RECAPP Facility Evaluation Report

Palliser Regional Division #26

County Central High School

Evaluation Company: Arup Datta Architect Limited
Evaluation Date: September 13 2005
Evaluator Name: Mr. Arup Datta

Event: Southwest exterior steps handrail missing

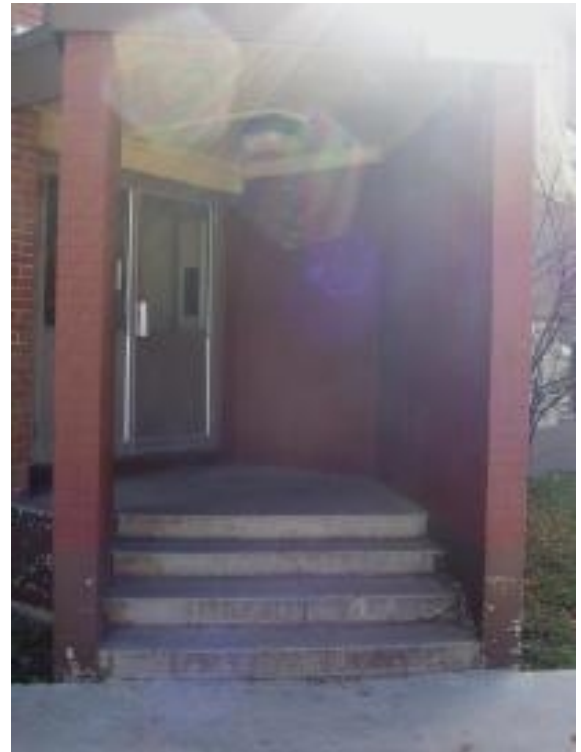
Concern:

Southwest exterior steps handrail does not exist making the steps unsafe
